IN THE DRAWINGS

Methods and Systems for the Evaluation of Power  
Generating Facilities

Inventor: Mark Anthony Juneau  
Attorney Docket No.: 17410-00010  
John S. Beulick Phone (314) 621-5070

FIG. 3

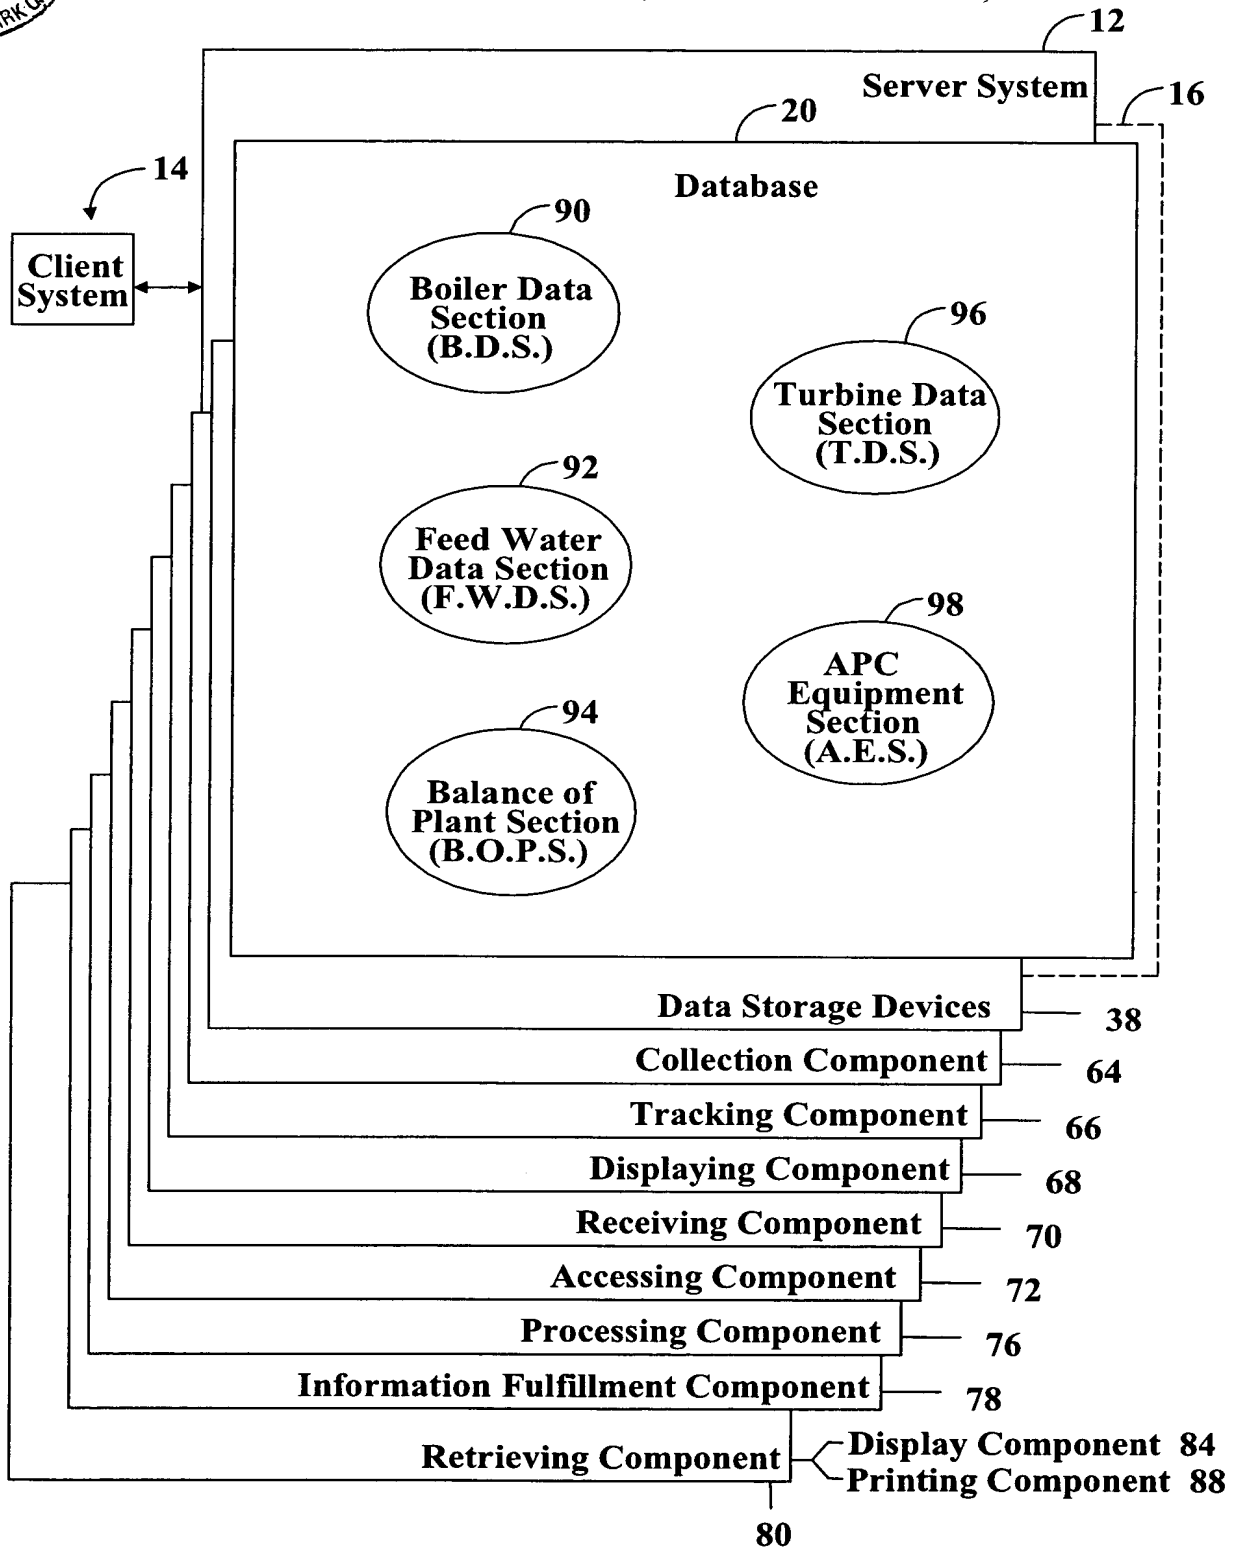
Applicant respectfully requests approval of the following drawing change. Figure 3 has been amended to correspond with the specification. More specifically, “Receiving Component” 80 has been changed to “Retrieving Component” 80 as described in the specification. No new matter has been added. Applicant hereby submits an “Annotated Copy” of Figure 3 showing the requested change in red permanent ink, and a “Replacement Sheet ” incorporating the change to Figure 3.
